CONTRACT CHANGE ORDER NO. 314S3
SHEET 2 OF 14

MARK	DATE	DESCRIPTIONS	BY	CH'D	CCO#
2	10/10/13	PIER E2 ROD TESTING	CC	MN	314S3
1	08/01/13	REMOVE AND TEST SAMPLE RODS	CC	MN	314S2
0	06/11/13	REMOVE, REPLACE, AND TEST SAMPLE RODS	CC	MN	314S1

SAN FRANCISCO OAKLAND BAY BRIDGE
EAST SPAN SEISMIC SAFETY PROJECT
SELF-ANCHORED SUSPENSION BRIDGE
(SUPERSTRUCTURE & TOWER)

TEST RIG DETAILS NO. 11

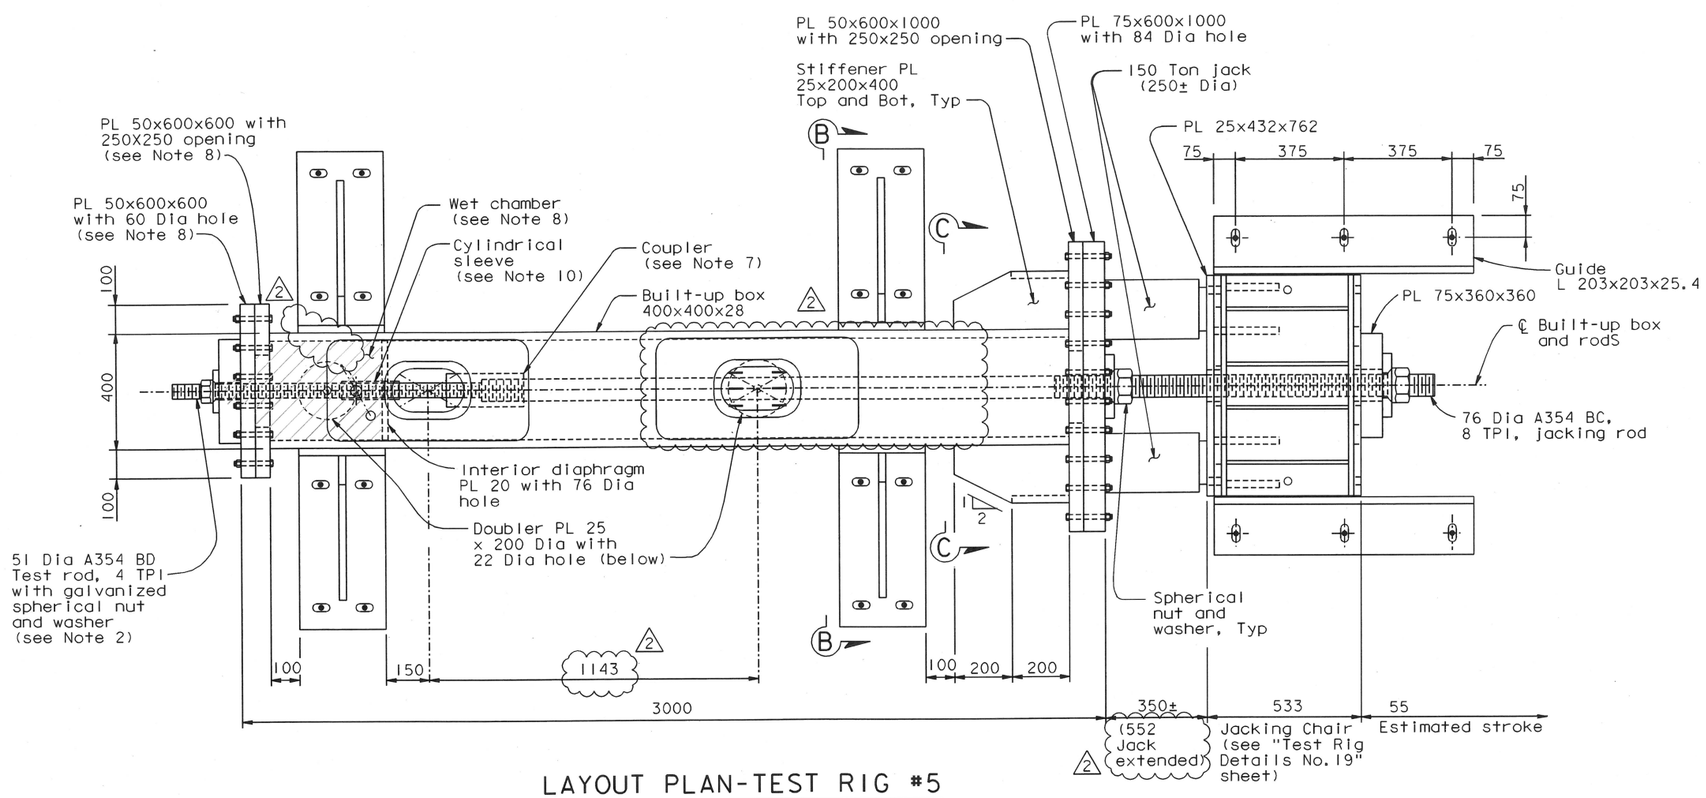
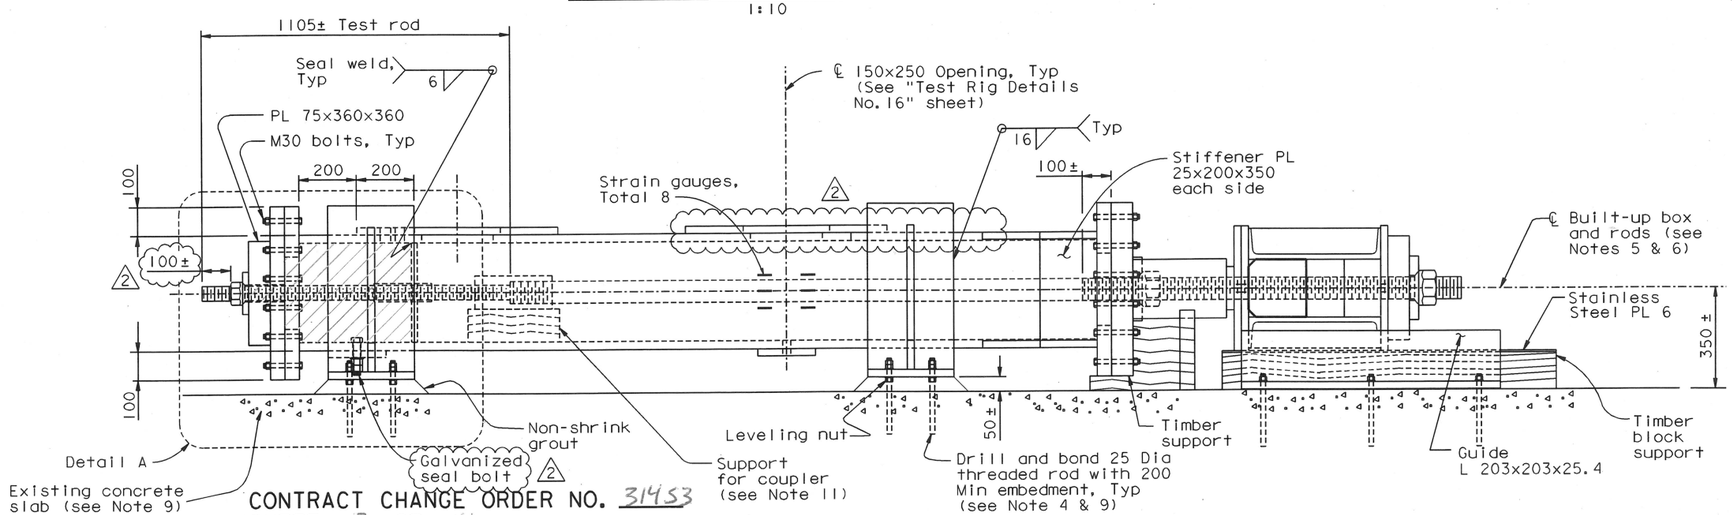
3. Built-up box 400x400x28 shall be used.
4. The drill and bond 25 Dia threaded rods shall have minimum allowable strength of 45 kN in tension and 30 kN in shear per threaded rod. Provide double nuts. Tighten per manufacturer's recomendation at the dead end and snug-tight against steel plates at the jacking end. (2)

TEST RIG DETAILS NO. 12

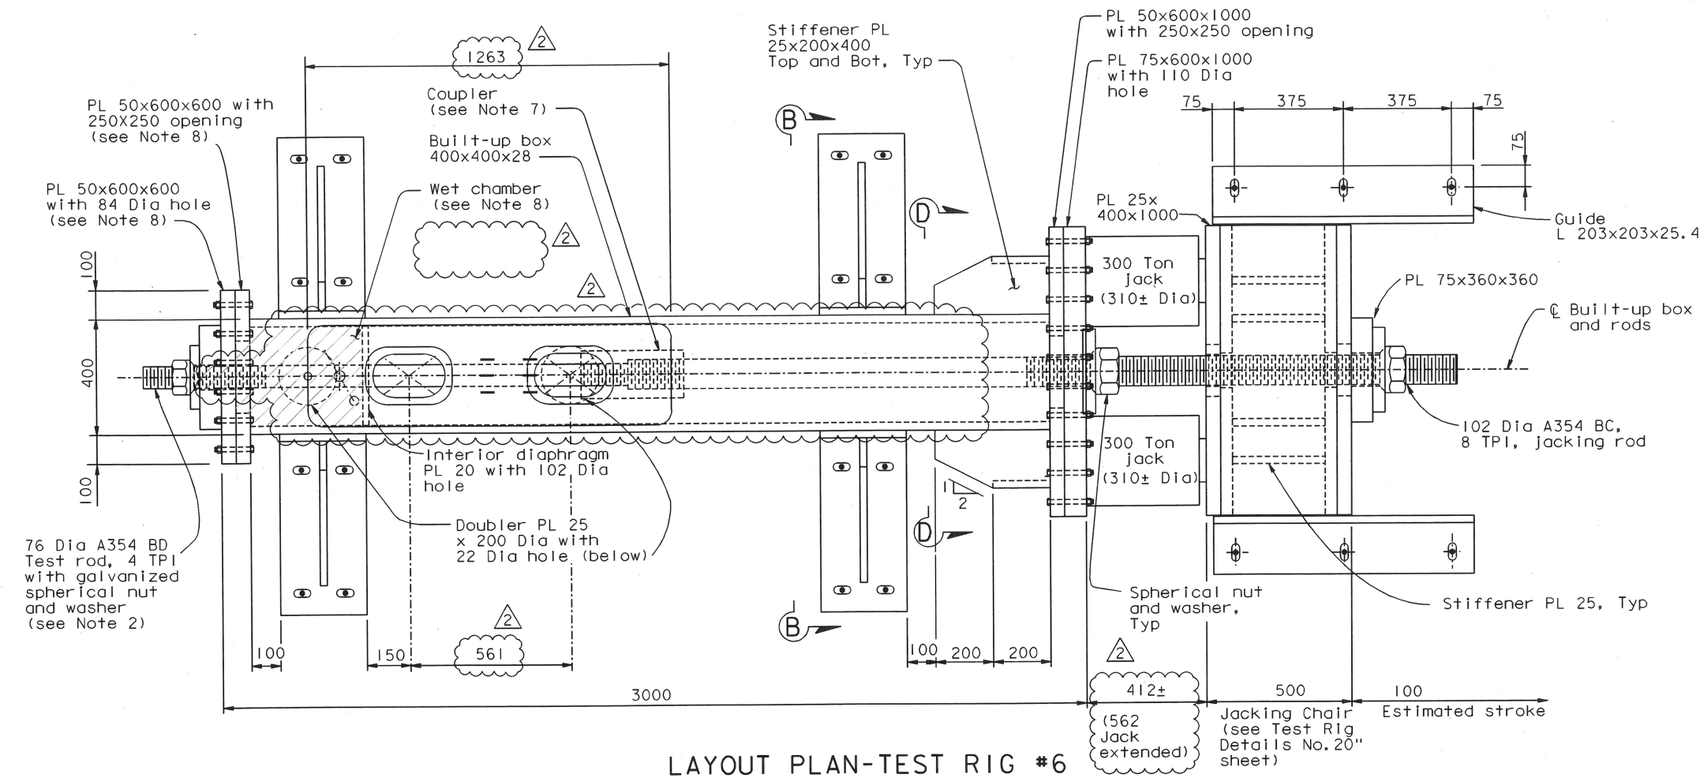
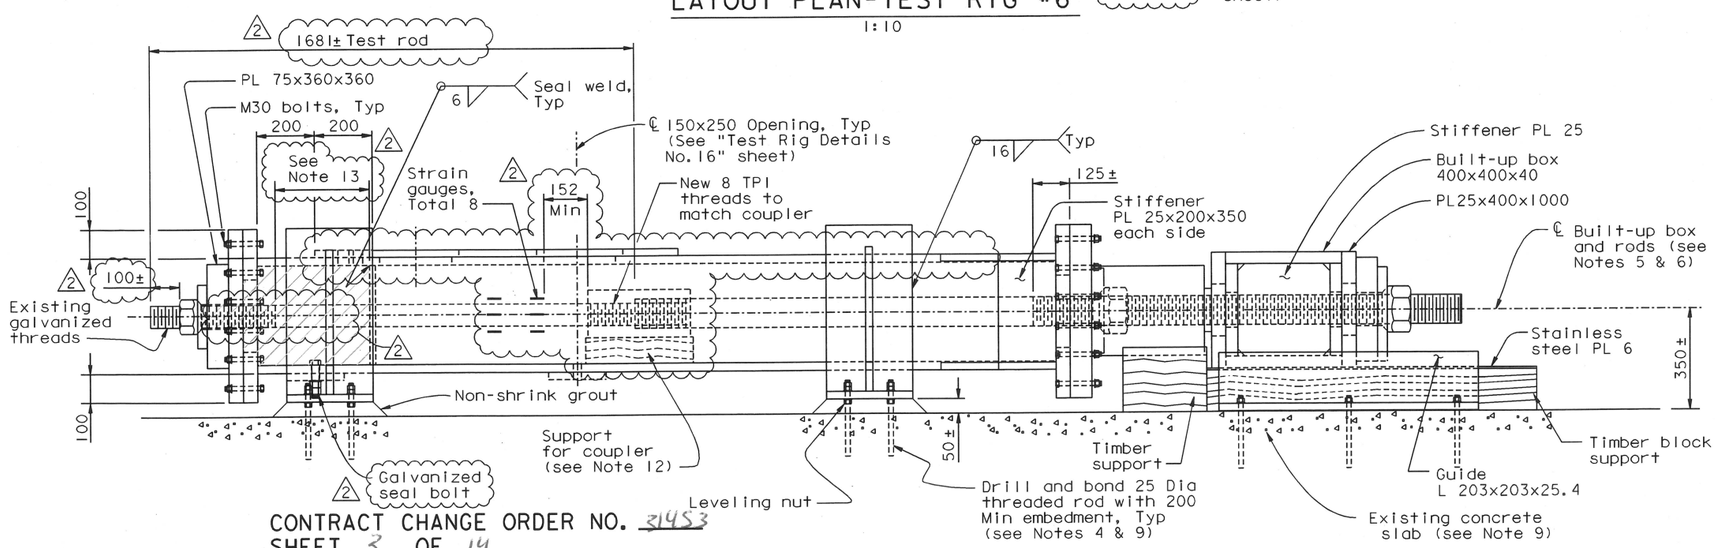
2. Minimum of 75 mm of threads of the rod shall be submerged in the NaCl solution at the start of the test.
3. Built-up box 400x400x28 shall be used.
4. The drill and bond 25 Dia threaded rods shall have minimum allowable strength of 45 kN in tension and 30 kN in shear per threaded rod. Provide double nuts. Tighten per manufacturer's recommendation at the dead end and snug-tight against steel plates at the jacking end. (2)

10. Note Deleted. (2)
11. Note Deleted.
12. Contractor to propose material for Engineer's review and approval. Material shall be non-metallic and non-expanding in contact with water.

13. End of threads shall be 200 Min Clr from the face of interior diaphragm. (2)

TEST RIG DETAILS NO. 13

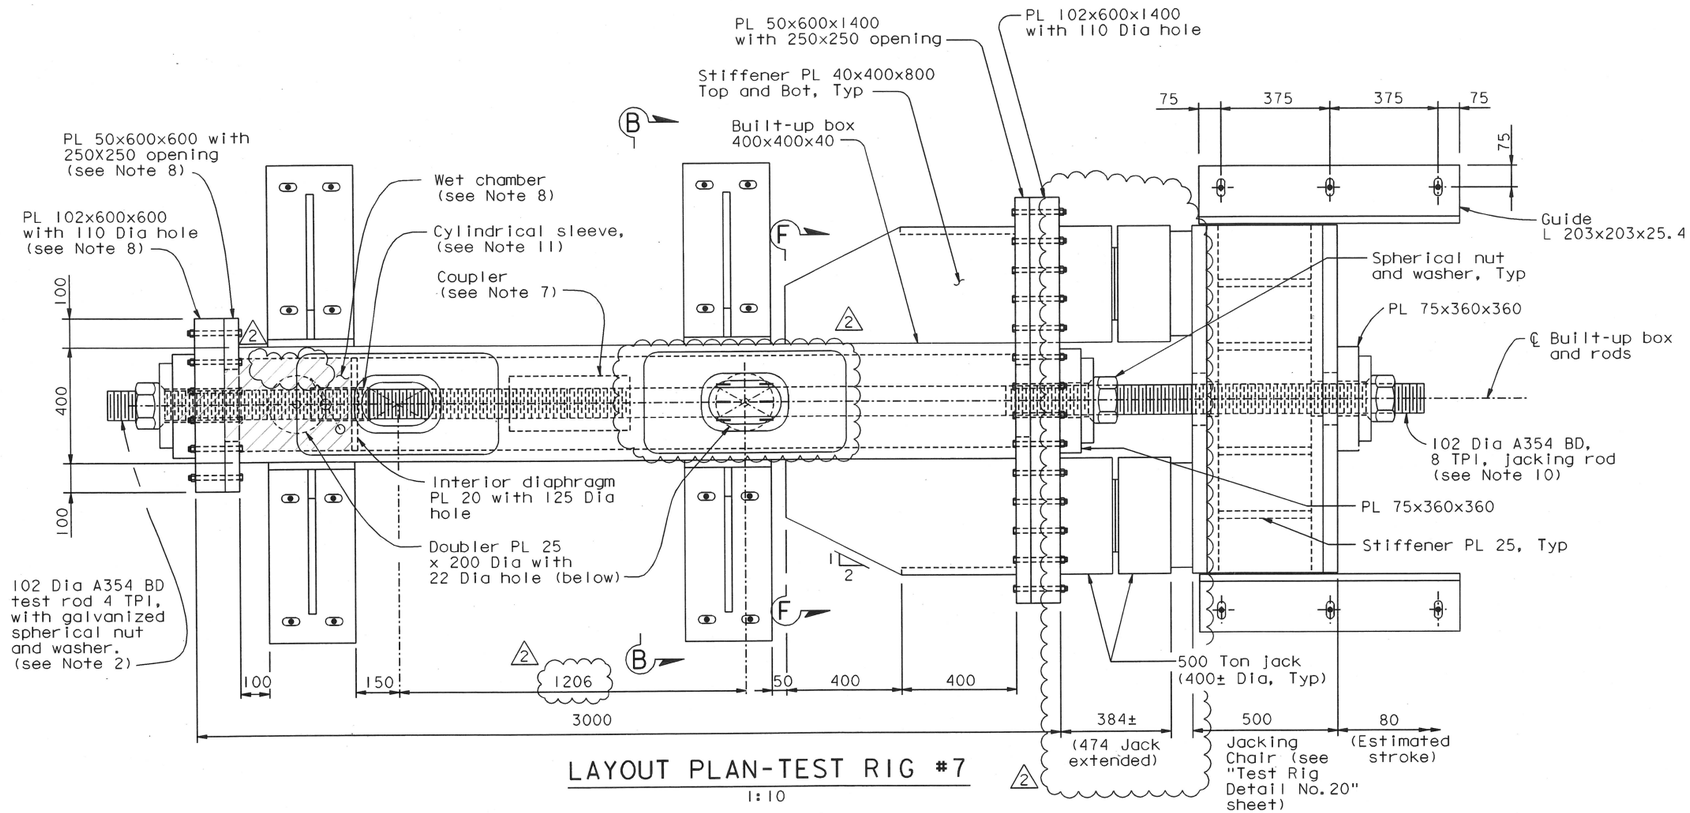
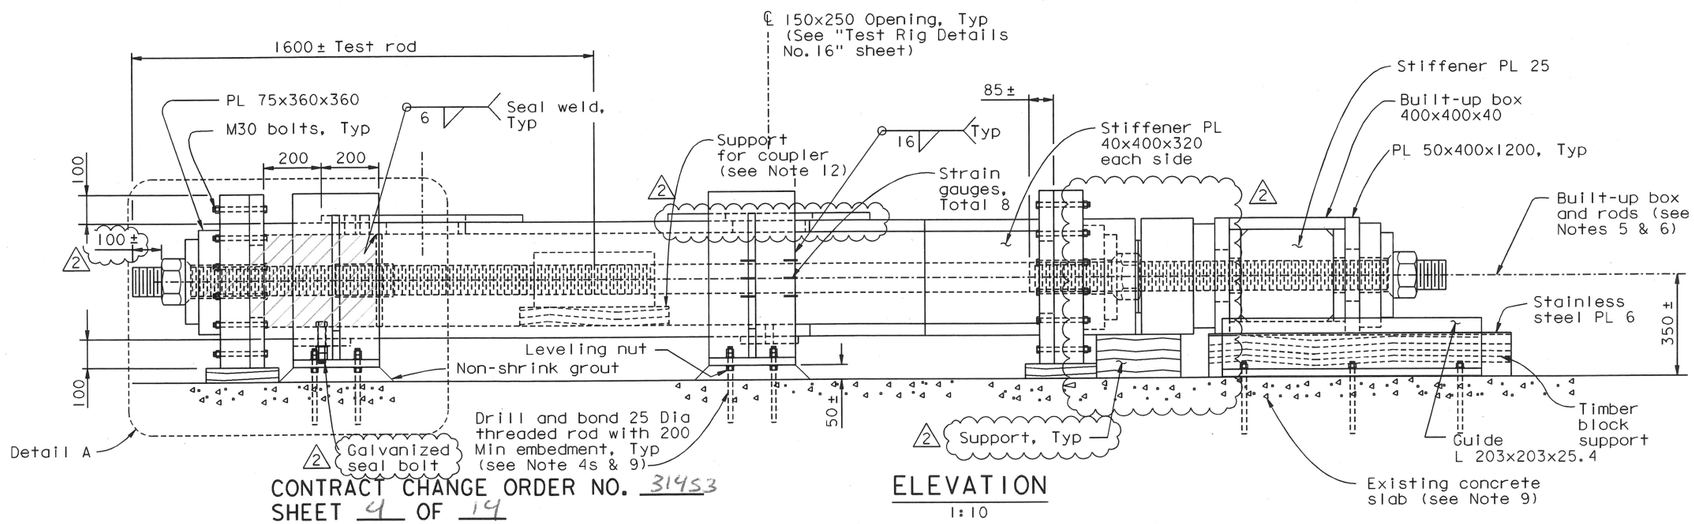
3. Built-up box 400x400x40 shall be used.
4. The drill and bond 25 Dia threaded rods shall have minimum allowable strength of 45 kN in tension and 30 kN in shear per threaded rod. Provide double nuts. Tighten per manufacturer's recommendation at the dead end and snug-tight against steel plates at the jacking end. 2

10. Provide mill certificate showing Fy of Jacking rod to be greater than 973 MPa (141 ksi). 2
11. For cylindrical sleeve details, see "Test Rig Details No. 16" sheet. Cylindrical sleeve shall be painted with two coats of epoxy based system or equivalent. Surface preparation and application procedure shall be per manufacturers' recommendations.

TEST RIG DETAILS NO. 14

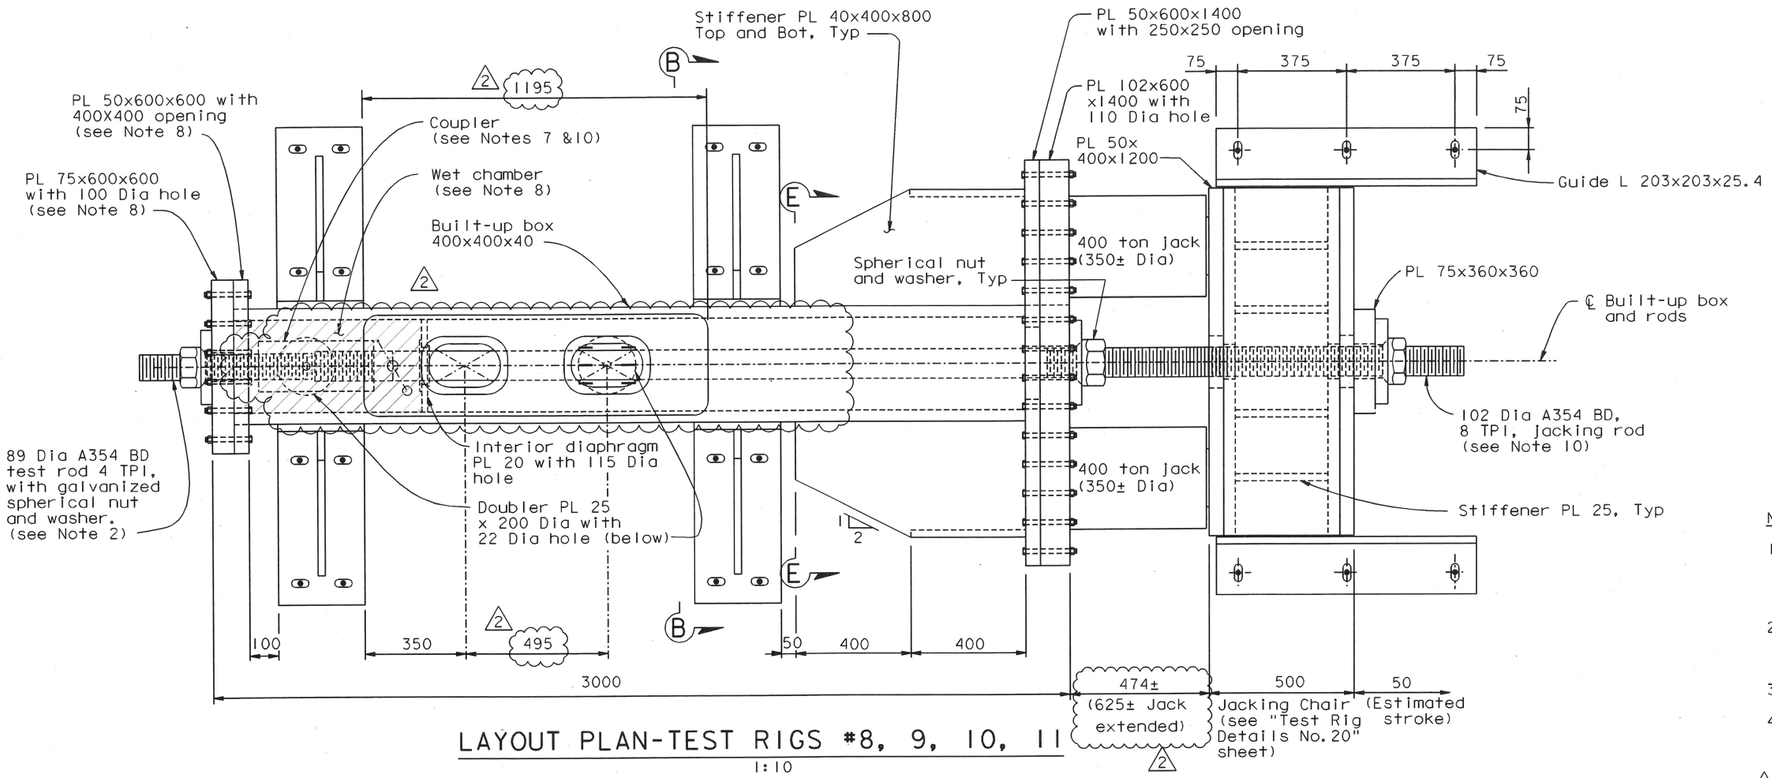
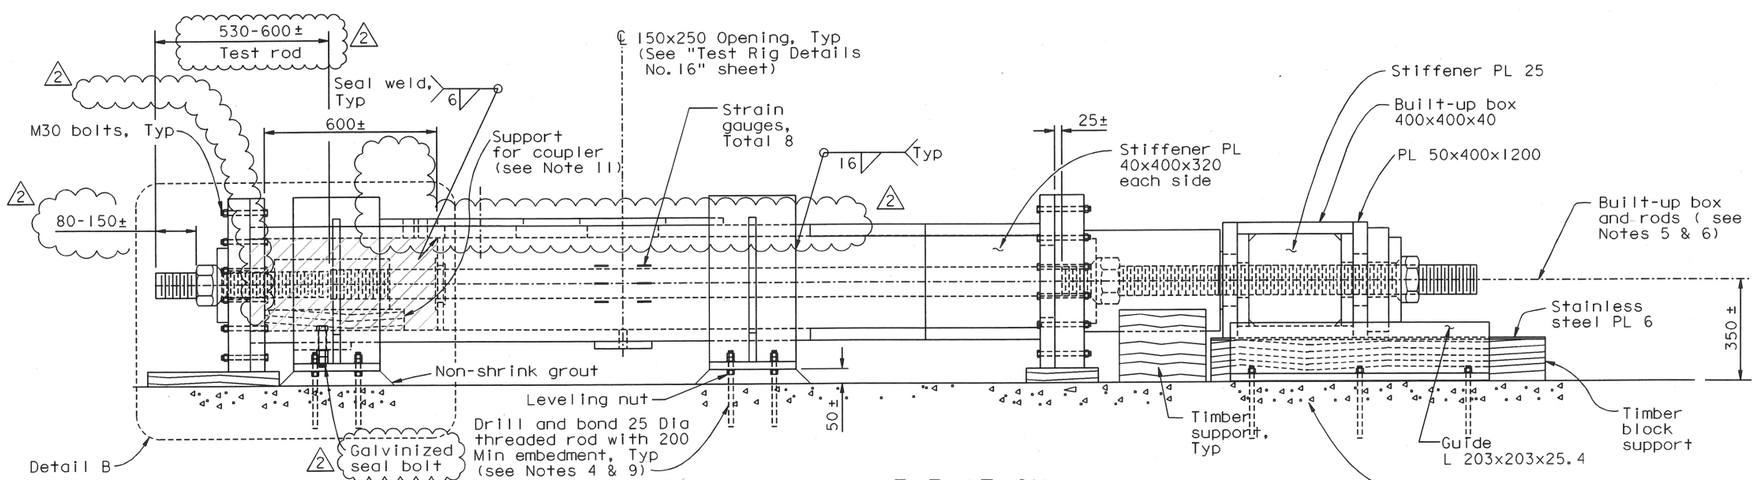
2. Minimum of 75 mm of threads of the rod shall be submerged in the NaCl solution at the start of the test.
3. Built-up box 400x400x40 shall be used.
4. The drill and bond 25 Dia threaded rods shall have minimum allowable strength of 45 kN in tension and 30 kN in shear per threaded rod. Provide double nuts. Tighten per manufacturer's recommendation at the dead end and snug-tight against steel plates at the jacking end. (2)

TEST RIG DETAILS NO. 16

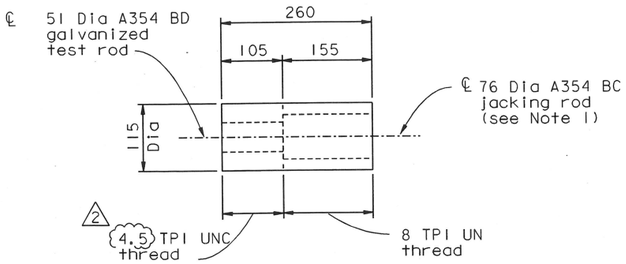
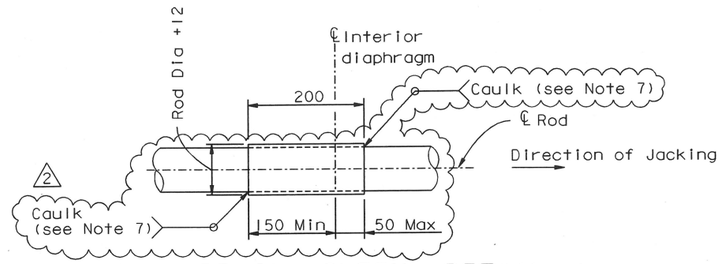
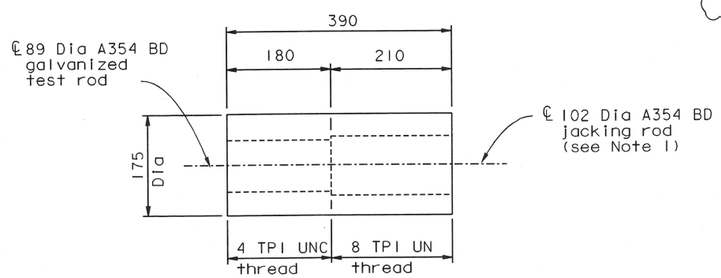
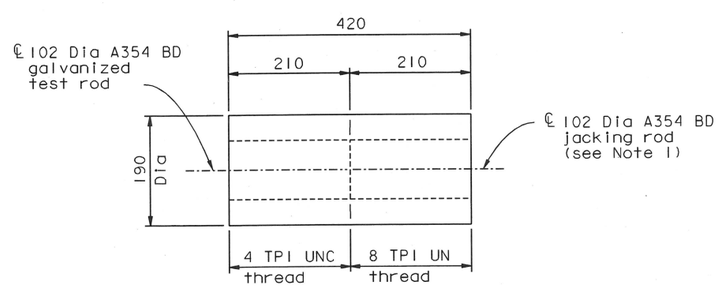
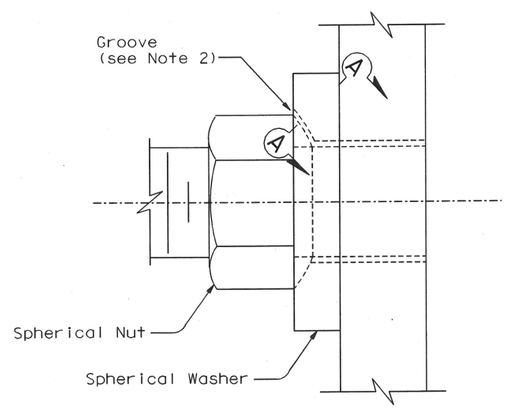
1. Coupler and jacking rod shall be fabricated from AISI 4340 materials, with mechanical properties conforming to ASTM A354 BC, (UNO.) Tapping of the coupler threads shall account for the thickness of galvanizing on the test rods. 2

3. New threads at this end of test rod shall not be galvanized.
4. Cylindrical sleeve shall be fabricated from AISI 1010 material. Inside of sleeve shall be tapped to be compatible with the threaded rod. 2

5. Apply (Rectorseal No.5 thread sealant) or equivalent to seal threads against leaks. Submit product (data sheet) for review and approval by the Engineer. 2

6. Holes required at wet chambers only. For locations, see "Test Rig Details No.11 thru No.14" sheets.
7. 2 Apply and tool Sikaflex 1A or equivalent all around to seal threads prior to painting. Submit product data sheet for review and approval by the Engineer.
